Memorandum

RE: **P.Z. 06-2022 17733 N. Outer Forty Road (Gateway Studios, LLC):** A request for a zoning map amendment from a “M3” Planned Industrial District to a “PC” Planned Commercial District for 34.02 acres located on the north side of Outer 40 Road (16V320056).

Planning Commission Staff Report

Re: PZ 06-2022 (17733 N. Outer 40 Road) – Response Letter
(Stock Project No. 221-7165)

Figure 4: Preliminary Development Plan

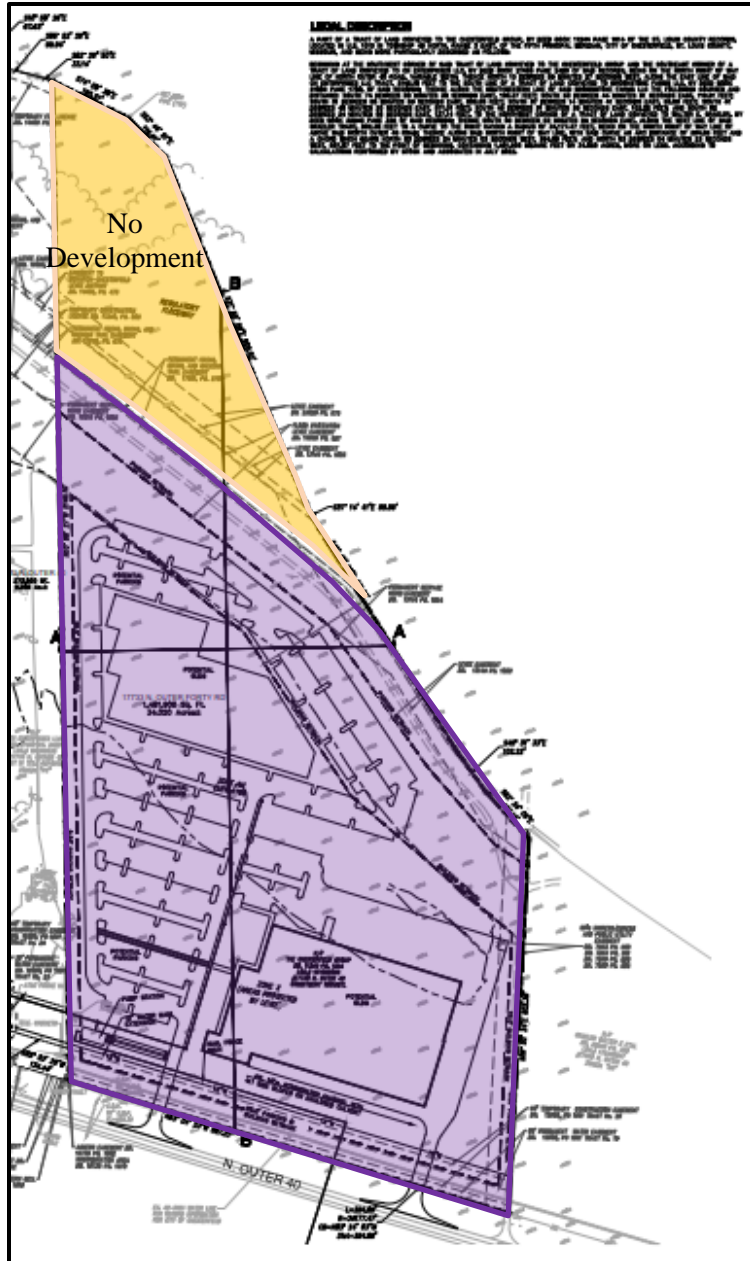
Concerns were raised about some of the proposed permitted uses. More specifically permitted uses; Arena and stadium, Grocery-Community, Grocery – Neighborhood, Financial Institution – Drive Thru, and Restaurant – Fast Food, Drive thru were discussed and recommended removing from the requested uses. Please provide an updated list of permitted uses eliminating the discussed uses.

Concern was raised regarding any future restrictions on the public access to the Levee trail that runs through the subject site. Provide information on how the development team will be addressing the above concern to provide future public access to the Levee trail.

Response: Provided updated project narrative and requested permitted uses.

Response: This Development "Does Not" intend to restrict the Public Access to the Levee Trail. A 50' ft wide Ingress/Egress utility easement exists on the east side of the property.

SHEET NO.:
PDP-1.0

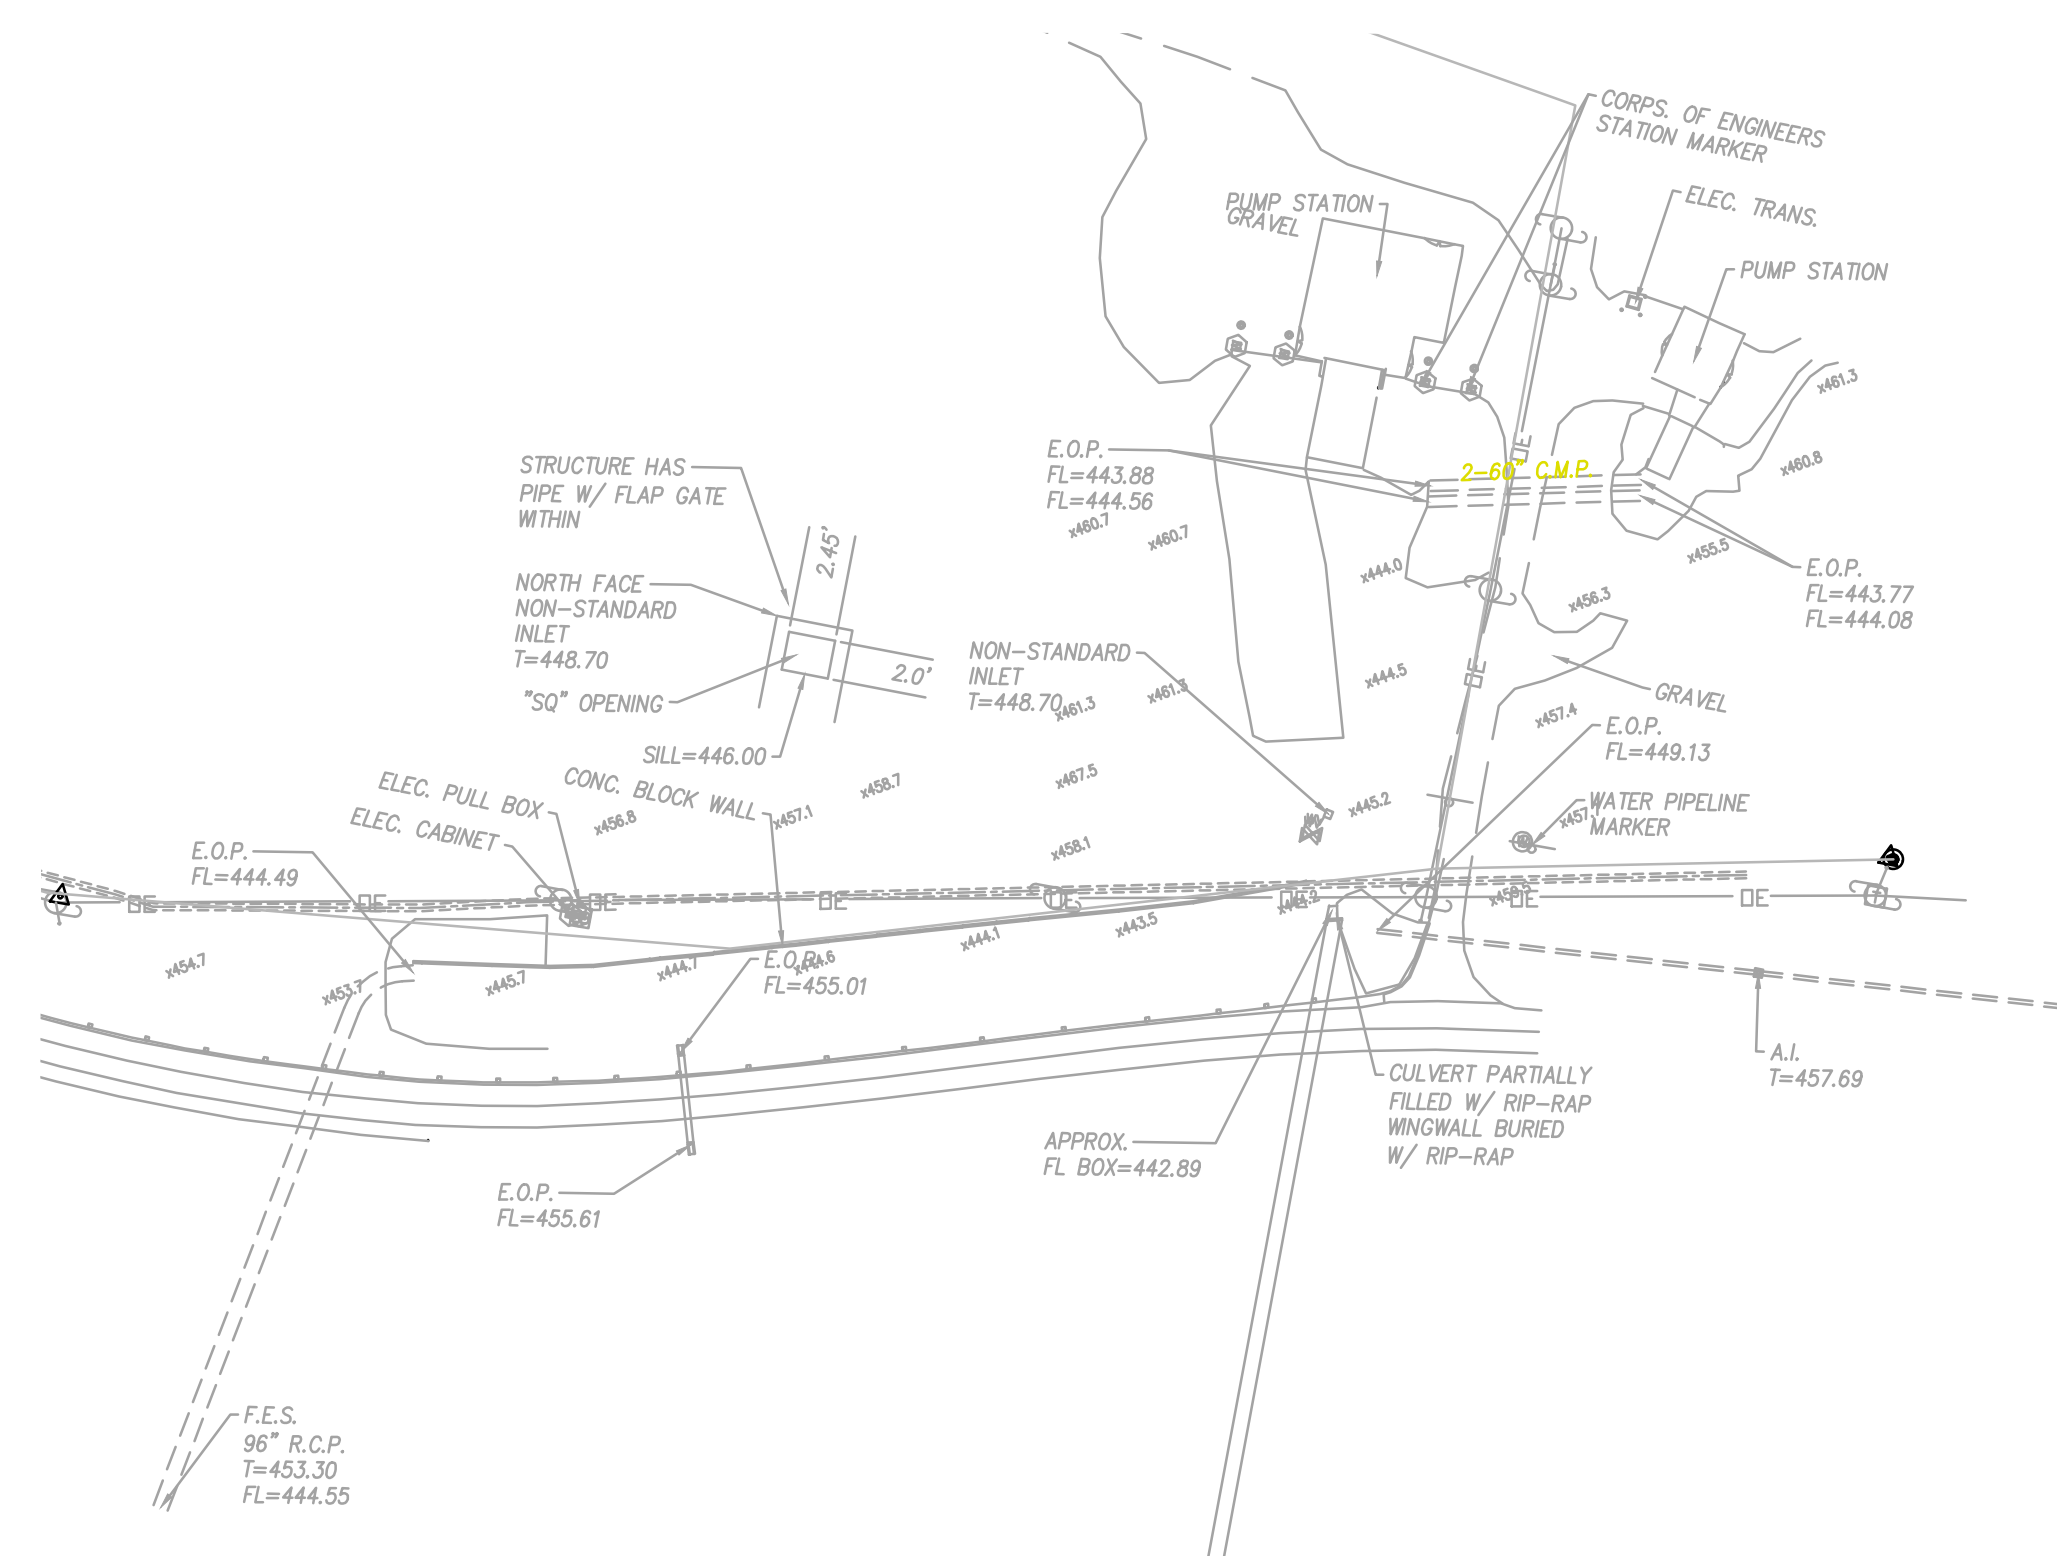
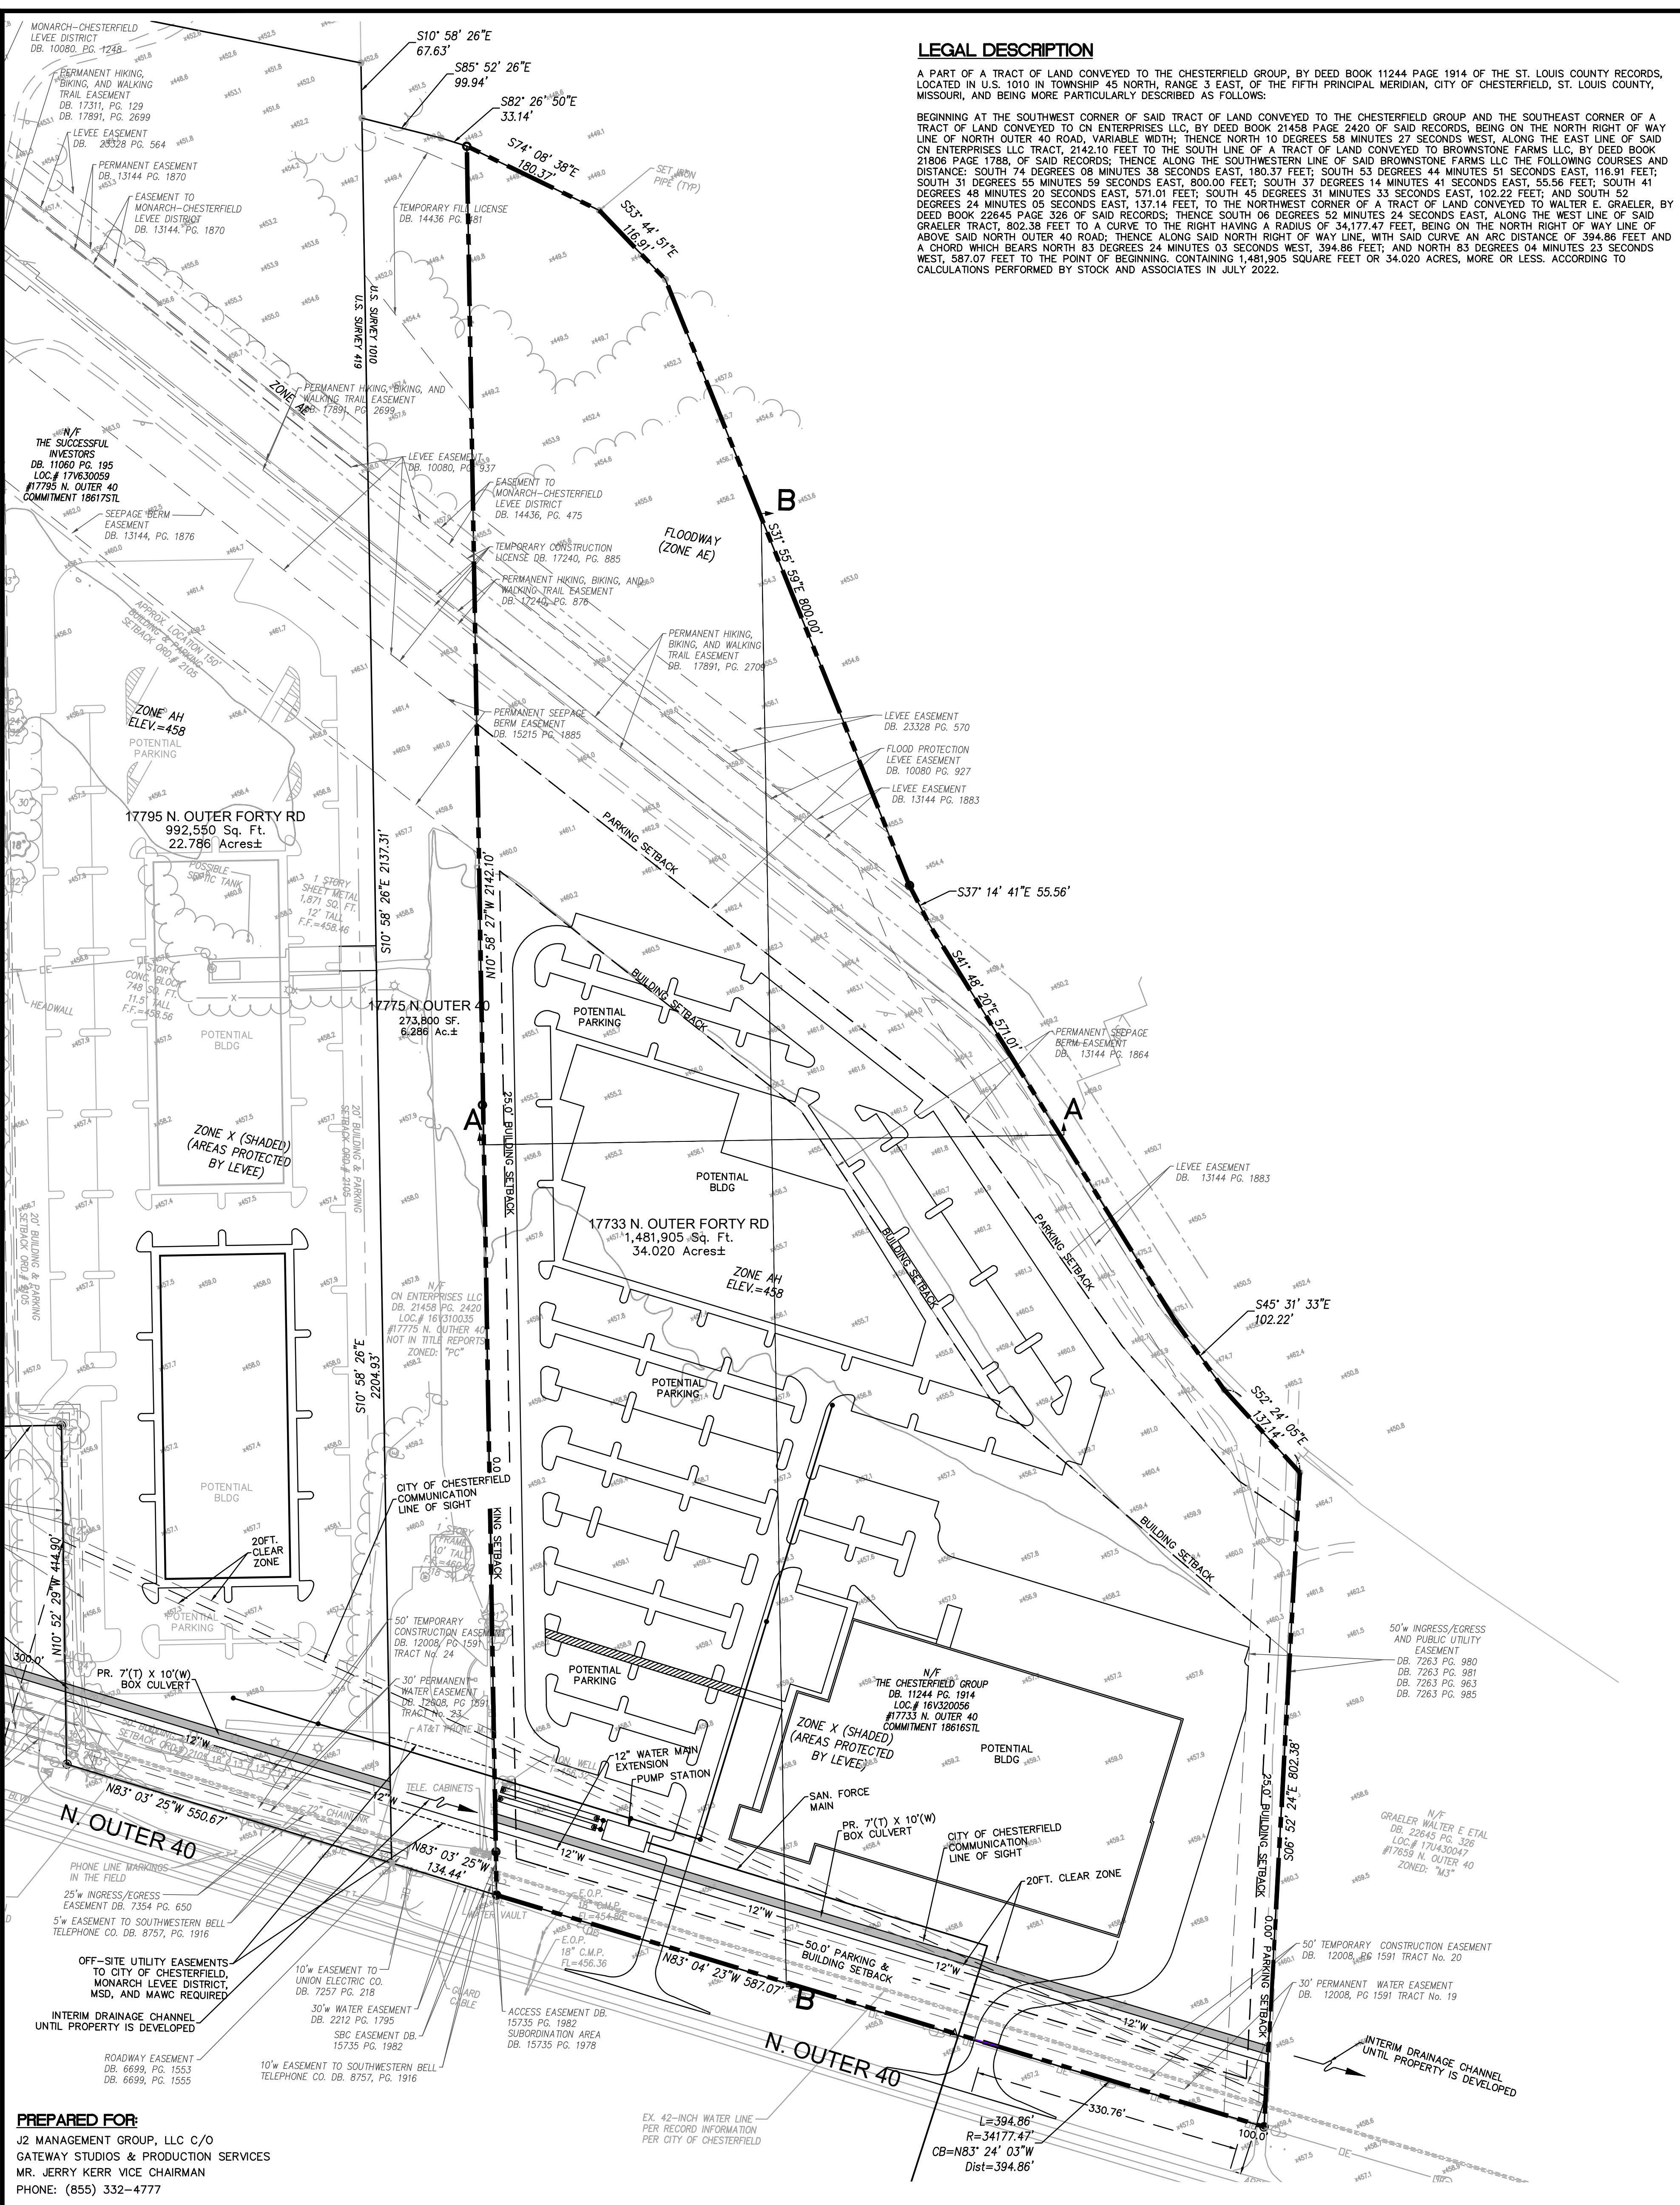
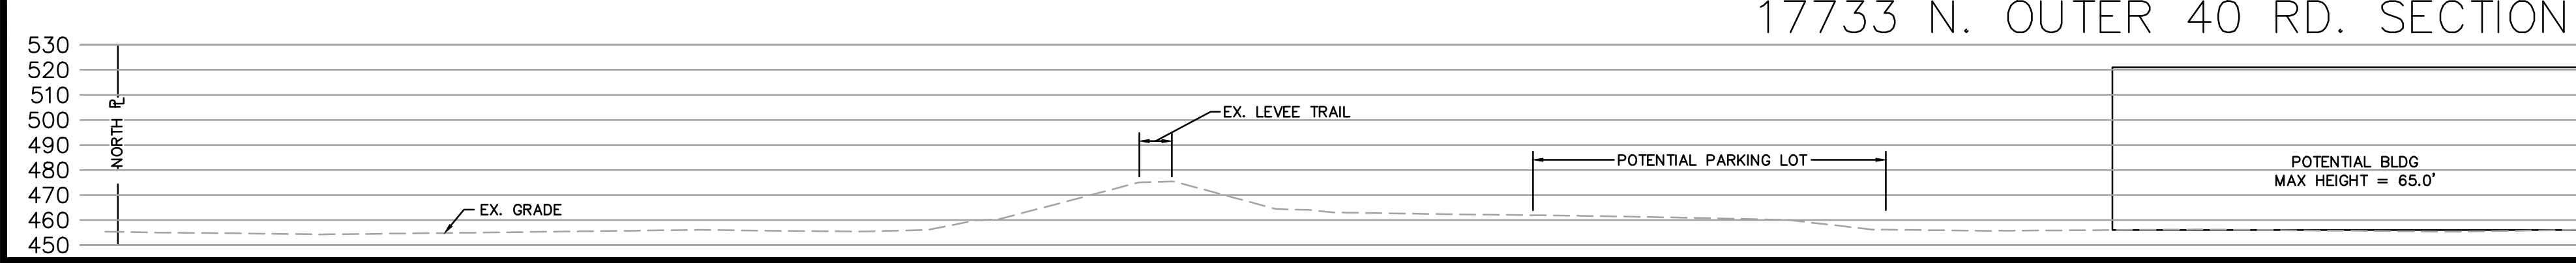
1. The distance between the existing gravel access drive along the eastern property line and the eastern proposed entrance does not meet the City's access management requirements. The required distance between these access points is 300 feet Please revise the plan as necessary.

2. If the location of the existing drive along the eastern property line is altered to meet the City's access management requirements, then new/revised access easements may be necessary. If this is the case, the preliminary plan should be revised to depict the necessary easements.

3. For the City of Chesterfield communication line of sight, a 20-foot-wide clear zone centered on the alignment shown is required. Anything located in the clear zone would need to be under 30 feet in height. The current preliminary plan only depicts a 10-foot-wide clear zone. Please revise the plan to provide a 20-foot-wide clear zone. As always, we appreciate your continued assistance and support for this project. Should you have any question or comments, please feel free to call.

Response: We have shifted the proposed access driveway to North Outer 40 to provide 300-feet from the existing gravel driveway located near the east property line.

Response: We do not intend to relocate the existing gravel driveway located adjacent to the East Property line.

Response: We have revised the Preliminary Development Plan to comply.
